Field Report No.:				21	
SP&A Project No: 22.331		Report Date: 1.28.2025		Time: 9:30AM	
Project: Gales Ferry School (Name & Location) 1854 CT-12 Gales Ferry, CT 06335 General Contractor: The Imperial Company, Inc.					
Weather		Site Conditions		Day of Week	
☐ Temp. Range: 238° ☒ Clear ☐ Rain ☐ Foggy ☐ Warm ☐ Overcast ☐ Snow ☐ Cold ☐ Hot		☒ Clear ☐ Dusty ☐ Muddy ☐ Windy ☐ Other		☐ Monday ☐ Thursday ☒ Tuesday ☐ Friday ☐ Wednesday ☐ Saturday	
Type of Work Observed Being Performed					
1	☐ Site work	7	☐ General Trades/Drywall	13	☐ Specialties/ Food Service
2	☐ Demolition	8	☐ Windows & Doors	14	☐ Elevators
3	☐ Concrete	9	☐ Roofing	15	☐ Plumbing
4	☐ Masonry	10	☐ Flooring	16	☐ HVAC
5	☐ Steel/Misc. Metals	11	☐ Pool	17	☐ Electrical
6	☐ Carpentry/Casework/ Mill Work	12	☐ Painting/Interior Finishes	18	☐ Temperature Controls/BMS
19	☐ Sprinkler	20	☒ Finish metal	21	☐ Iron workers
		22	☐ Tester (Tri-state)	23	☐ Audio Vis/Low Volt

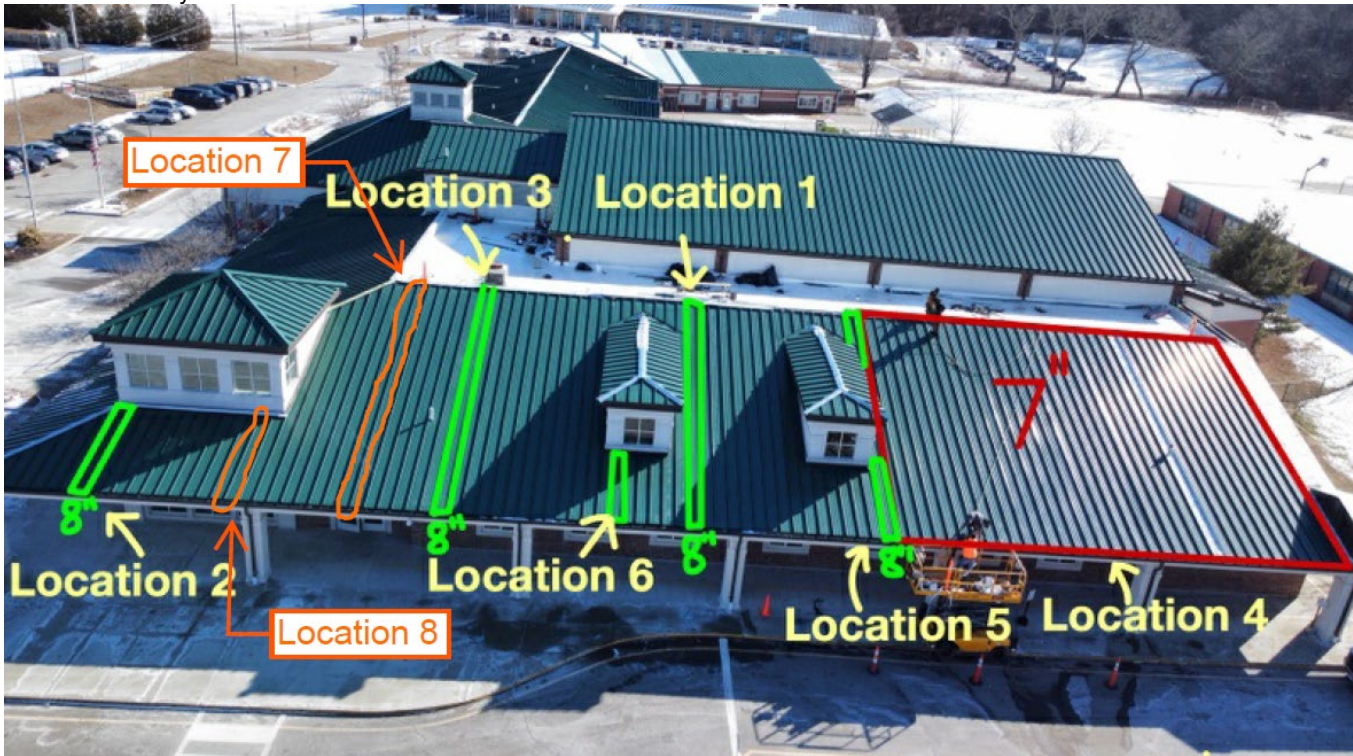
- <i>Past issues that need to be resolved</i> - Panels that were installed and have short screws that need to be replaced need to be observed for the correct screw length by Garland & SPA in areas where the underside decking is not visible. See attached photo. - <i>Past issues that need to be resolved</i> - Roof A – Gable end of walkway cover needs the lower 8" of the vertical panels (all three sides) removed for investigation of how to secure the new vertical panels to the existing structure and height requirements. Imperial to remove material for exploration. - <i>Past issues that need to be resolved</i> - At the gable end of the walkway roof, Garland needs to produce a drawing eliminating the current cricket for better flow of the rainwater. Currently the water hits vertical end points at both sides of the cricket. - <i>Past issues that need to be resolved</i> - Garland needs to produce a design for where the rake boards meet with the roof at one of the gable roofs. See attached photo. - <i>Past issues that need to be resolved</i> - Garland needs to produce a design for the rakes where there is not enough structure to support the vertical clip.
